SINGAPOREAN NOTICES TO MARINERS

NM 9/2020

| CORRECTION NO. | SNM EDN NO. | LAST CORR N NO. | CHART NO. | Location on Chart | | |
|----------------|-------------|-----------------|-----------|-------------------|--|--|
| 9 | 3/2020 | - | GSP1/SP1 | X | | |

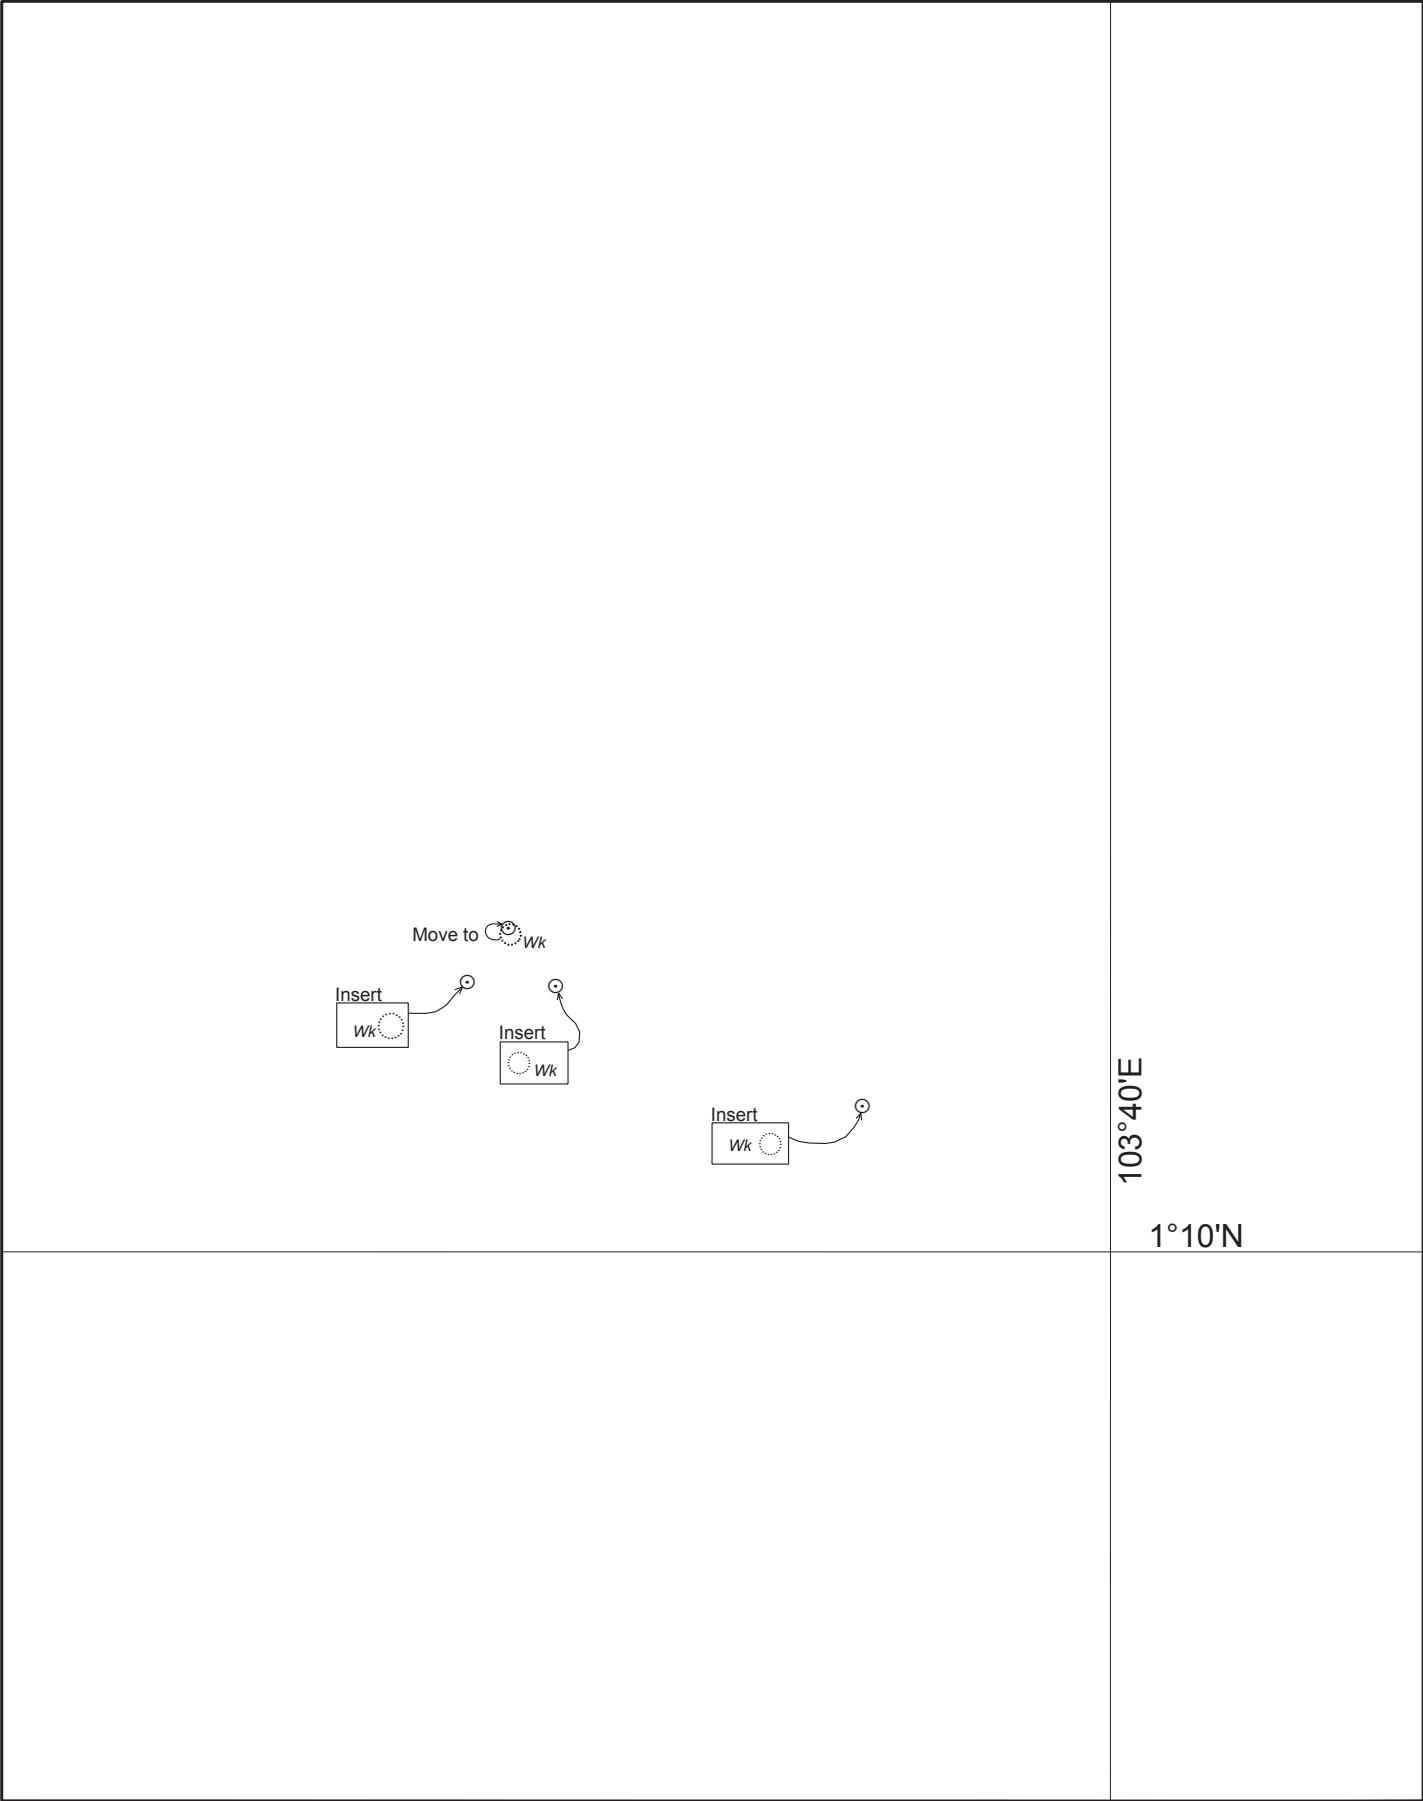
GSP1/SP1 4 Ed 15/2/20

Move

from : 1°11·48'N 103°37·22'E
to : 1°11·51'N 103°37·21'E

Insert

1°11·26'N 103°37·02'E
1°11·24'N 103°37·43'E
1°10·68'N 103°38·85'E

| CORRECTION NO. | SNM EDN NO. | LAST CORR N NO. | CHART NO. | Location on Chart | | |
|----------------|-------------|-----------------|-----------|-------------------|--|---|
| 9 | 3/2020 | 85/2019 | 201 | | | X |

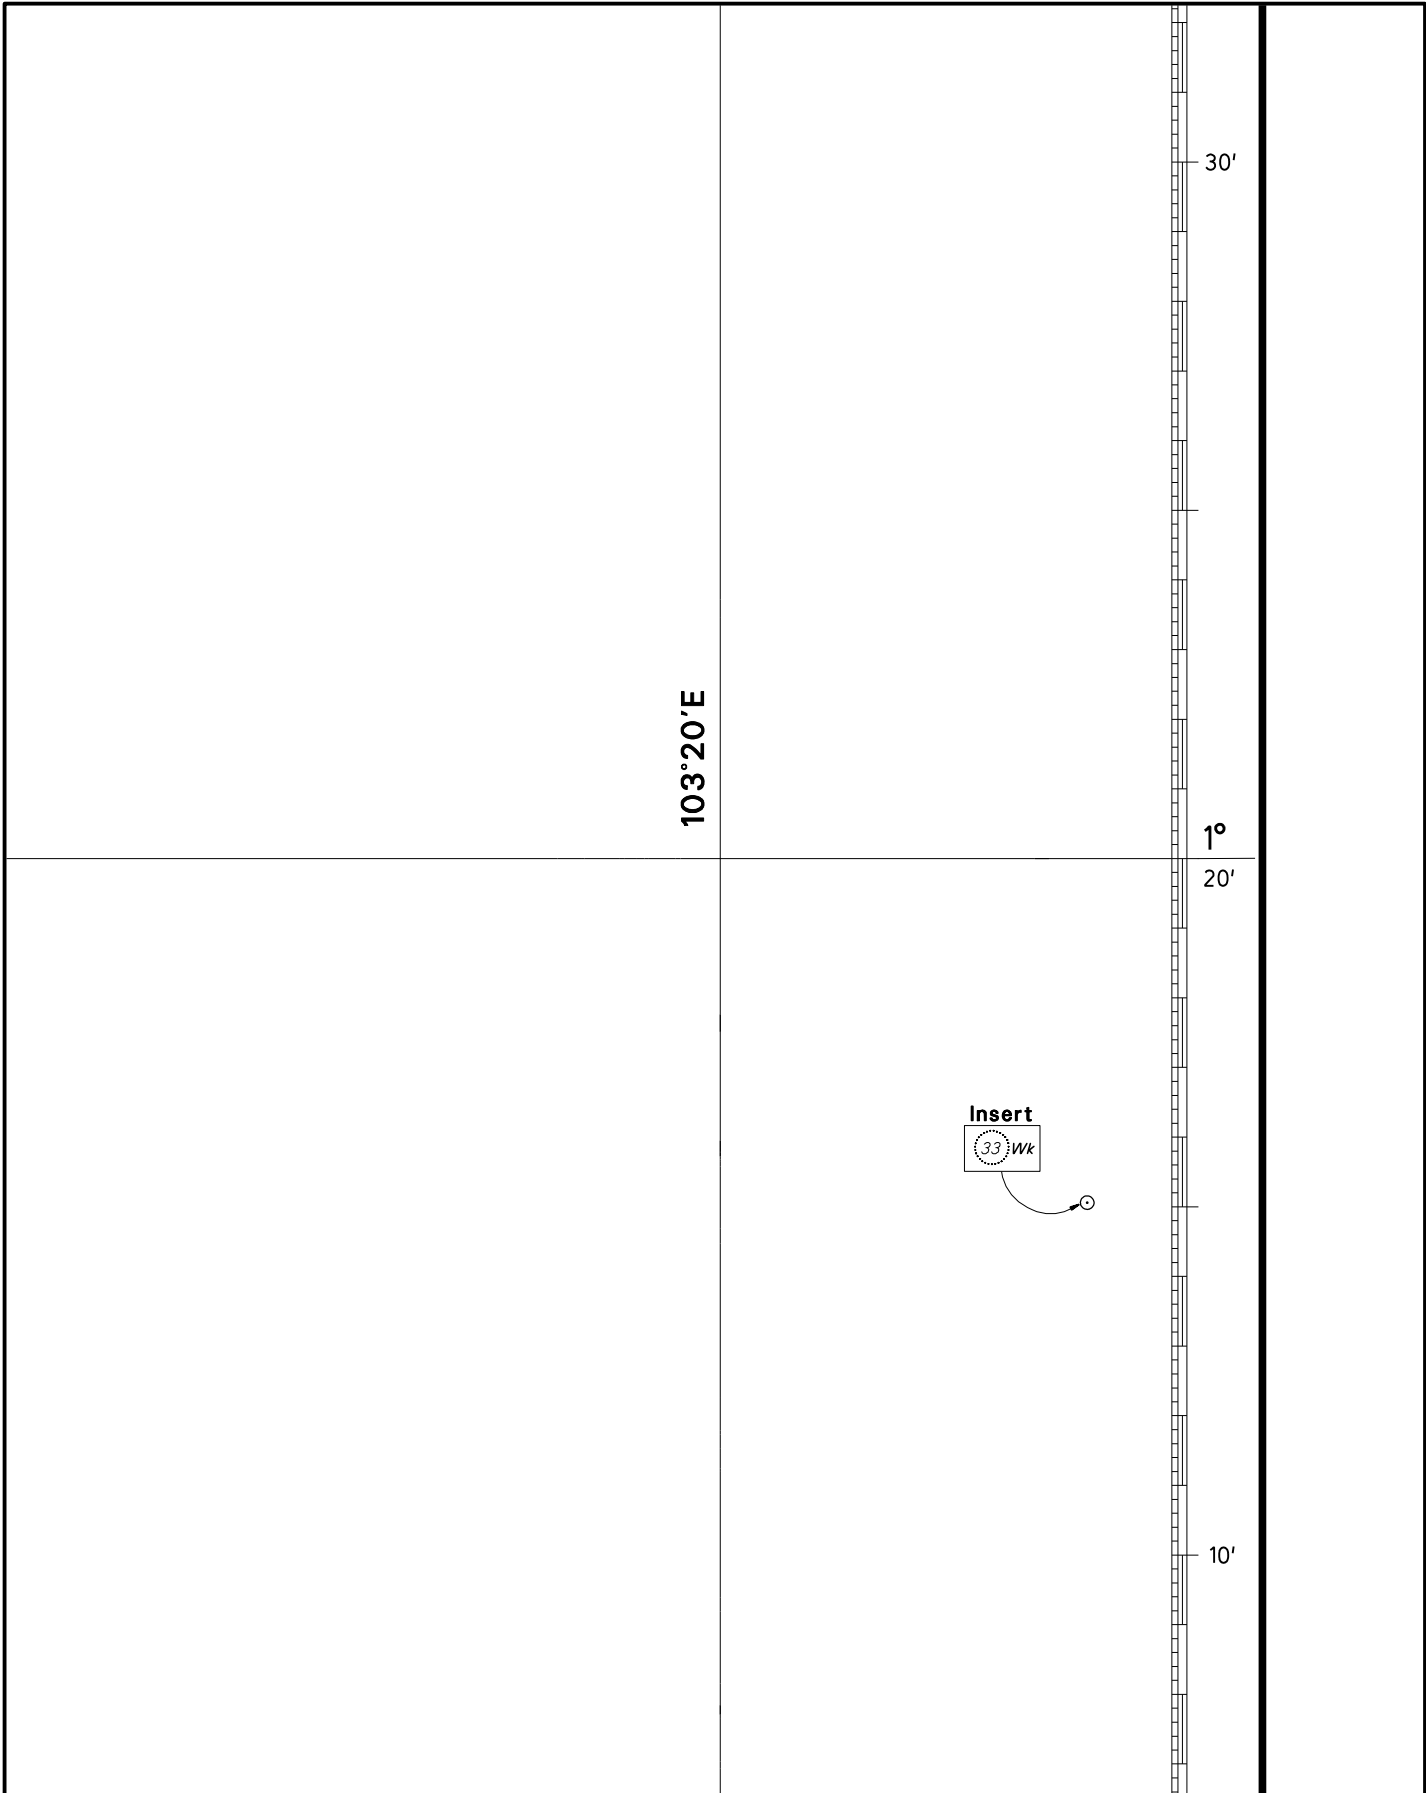
201

Insert

1°15·06'N 103°25·24'E

| CORRECTION NO. | SNM EDN NO. | LAST CORR N NO. | CHART NO. | Location on Chart | | |
|----------------|-------------|-----------------|-----------|-------------------|--|--|
| 9 (Sheet 1) | 3/2020 | 85/2019 | 202 | X | | |

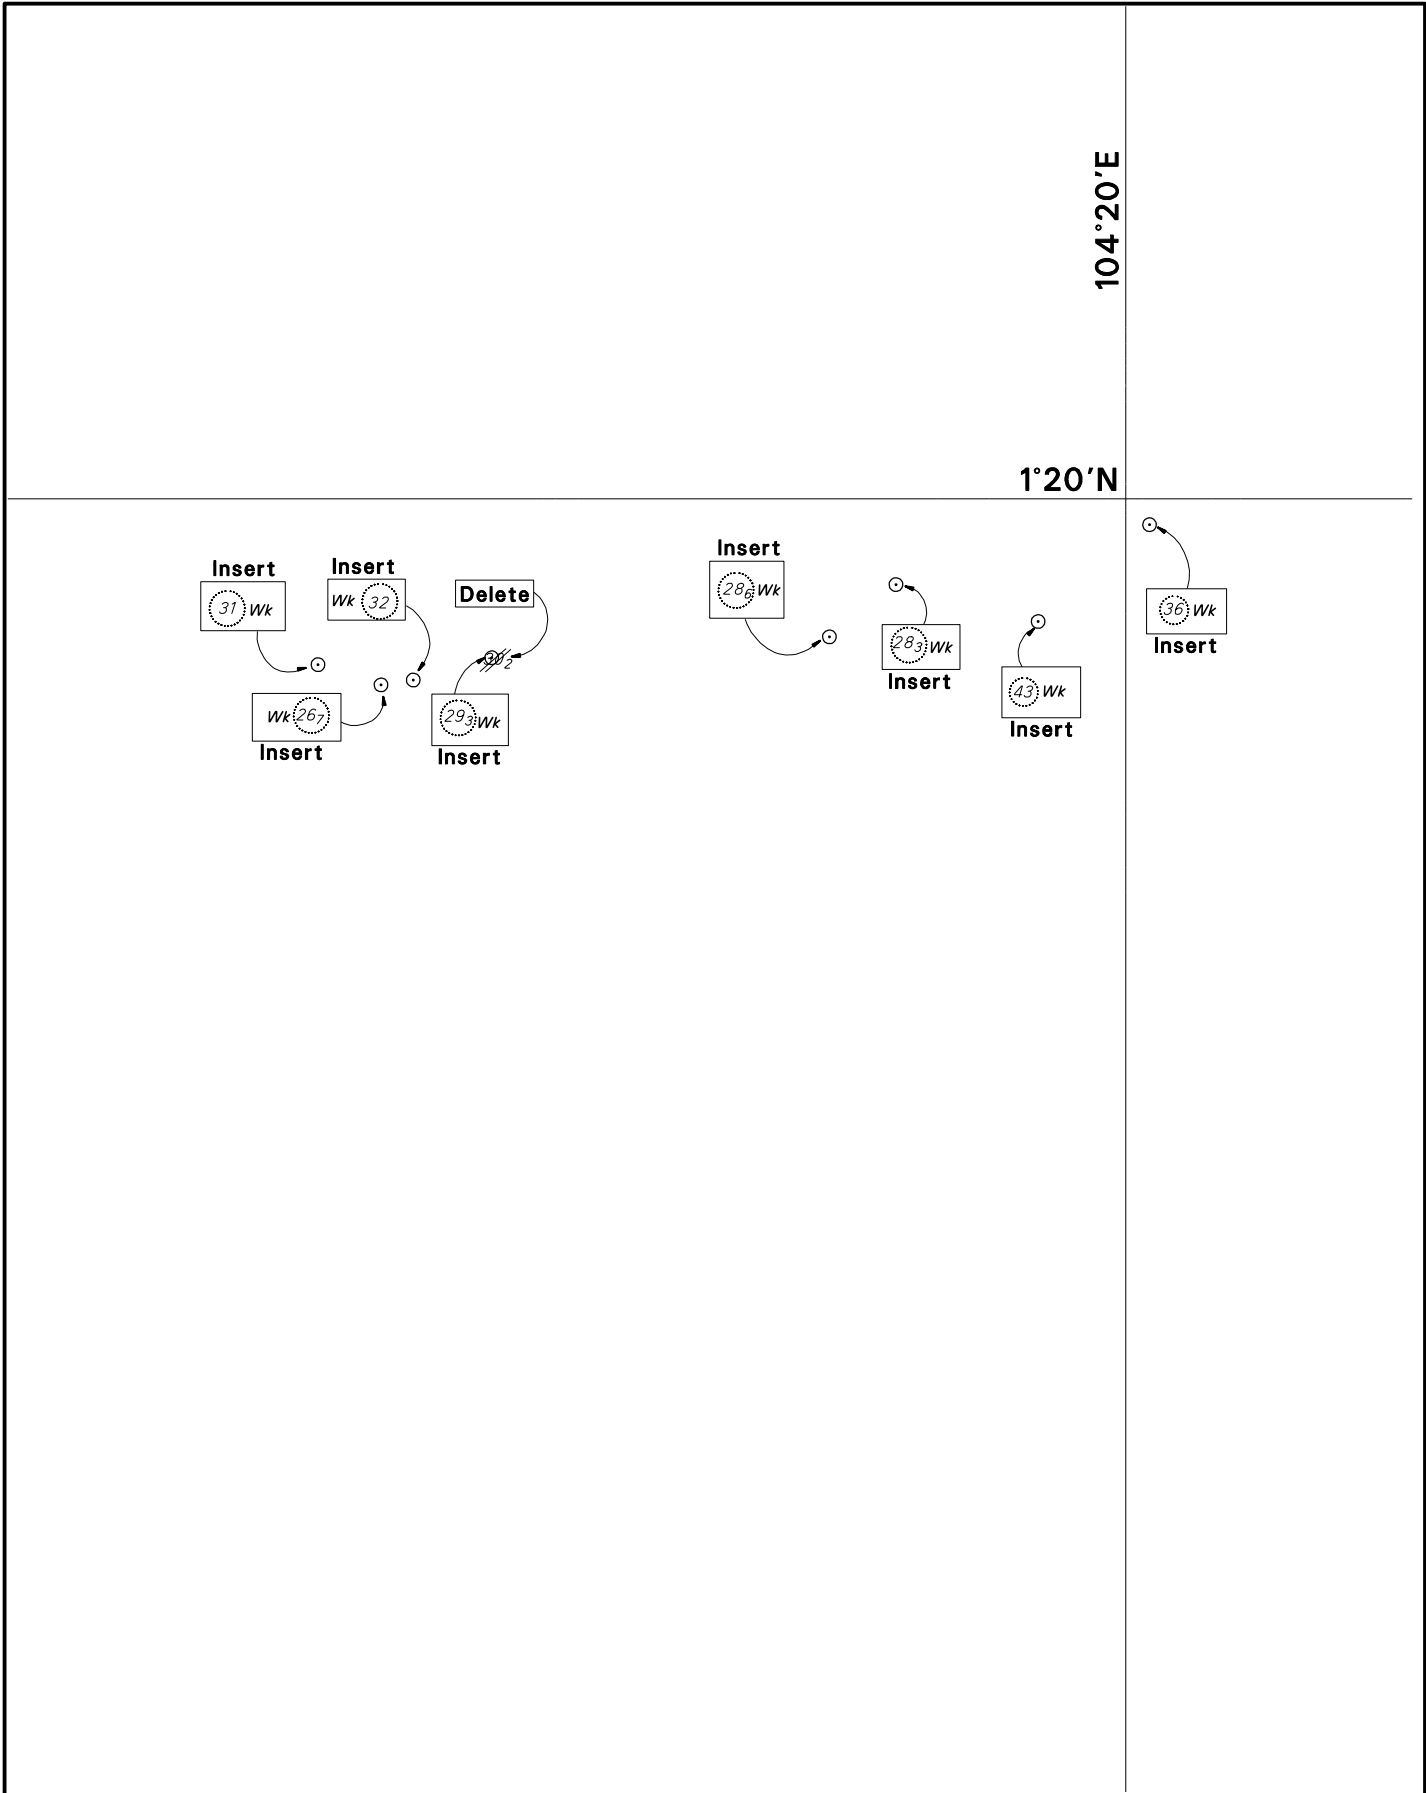
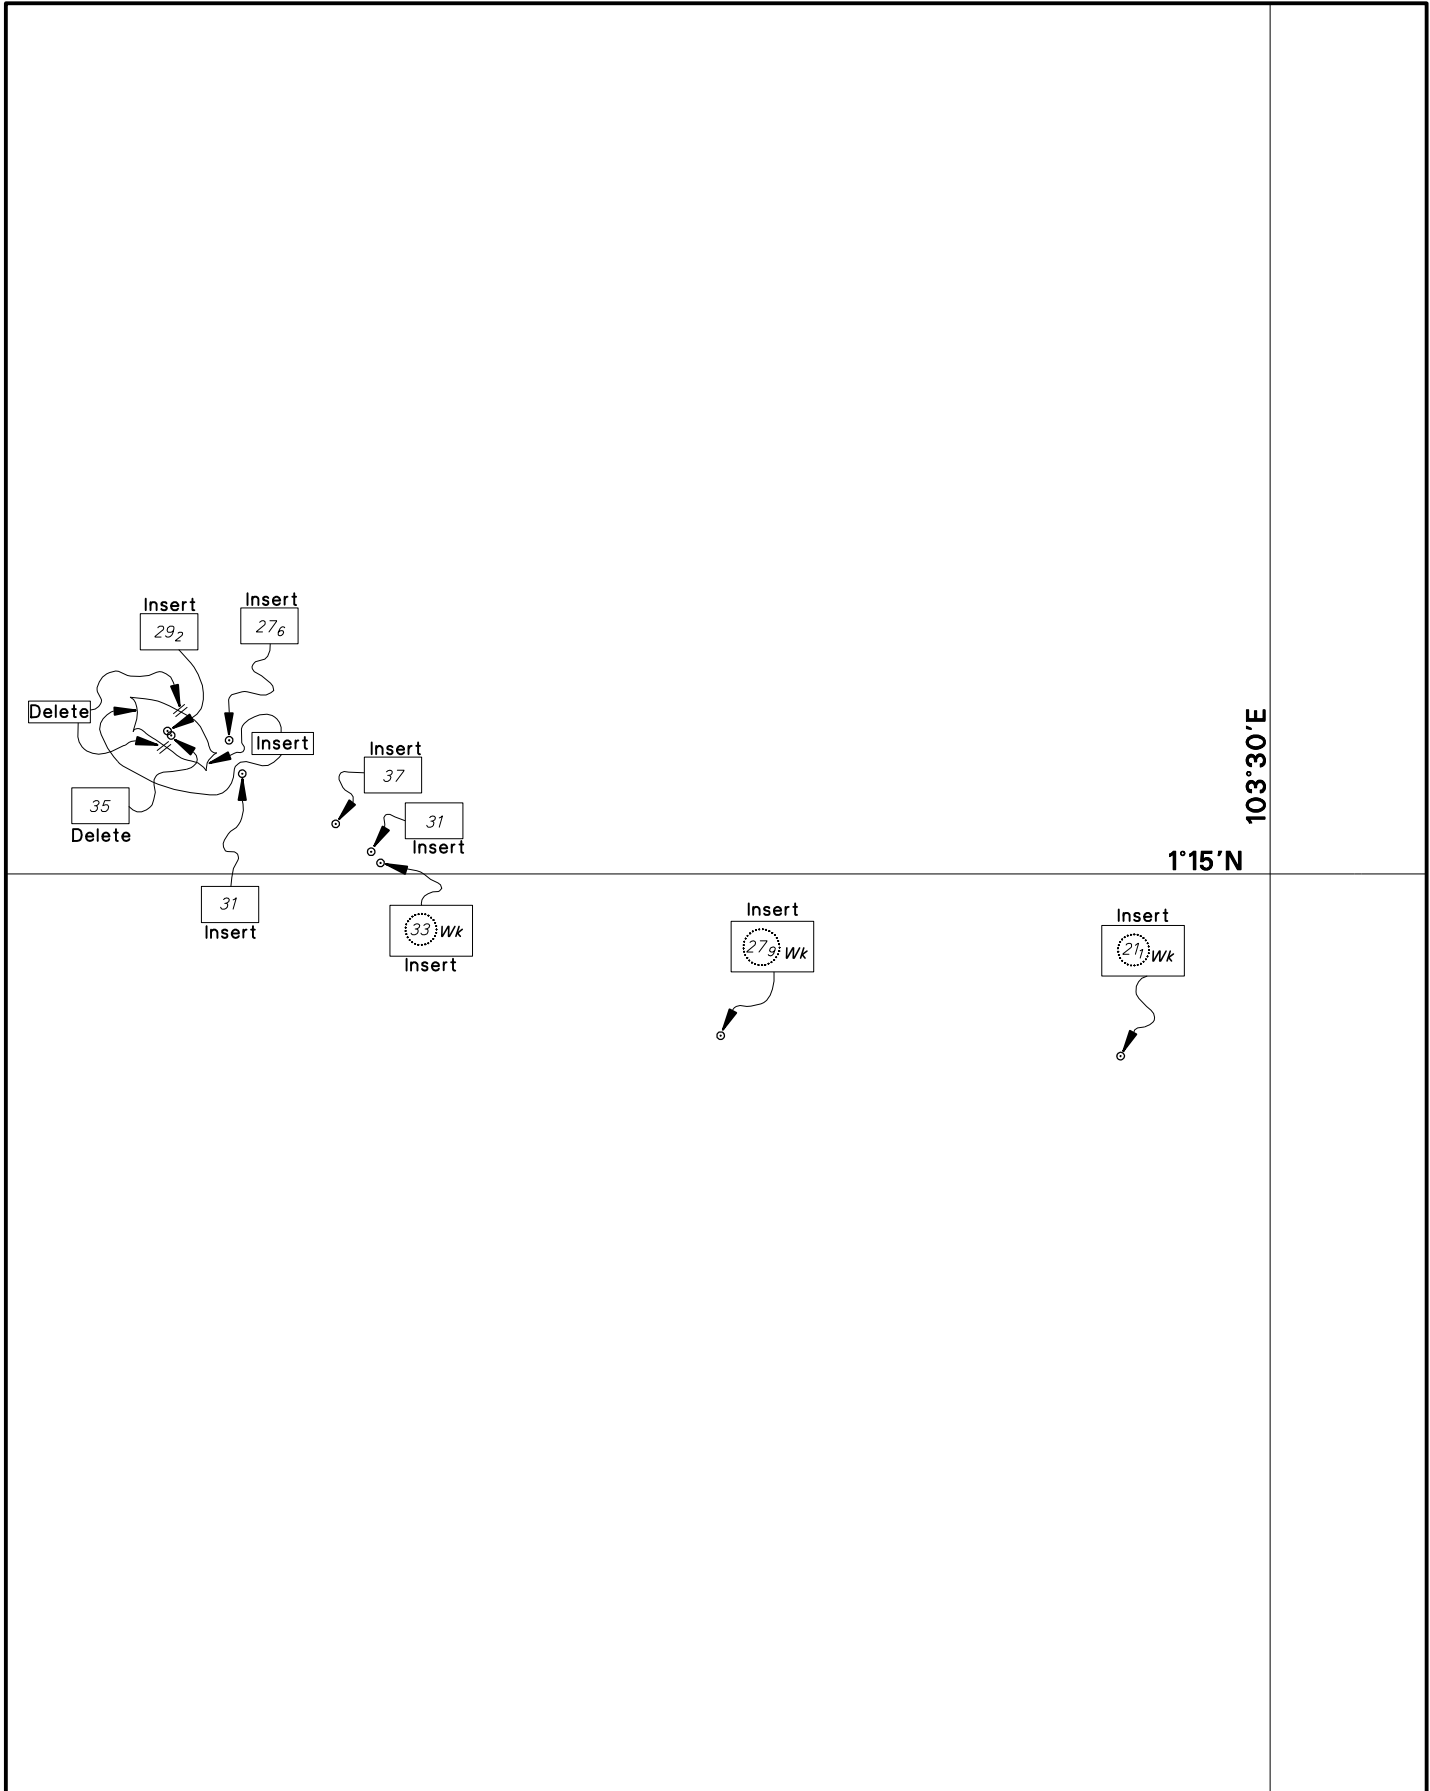
202

Delete

1°11·48'N 103°37·22'E

depth, 30₂

1°17·72'N 104°10·95'E

Insert

1°15·06'N 103°25·24'E

| Insert |  <i>Wk</i> | 1°17.72'N | 104°10.95'E |
| |  <i>Wk</i> | 1°19.63'N | 104°20.34'E |
| | depth, <i>34</i> | 1°11.30'N | 103°36.16'E |
| | depth, <i>28₅</i> | 1°10.82'N | 103°34.94'E |
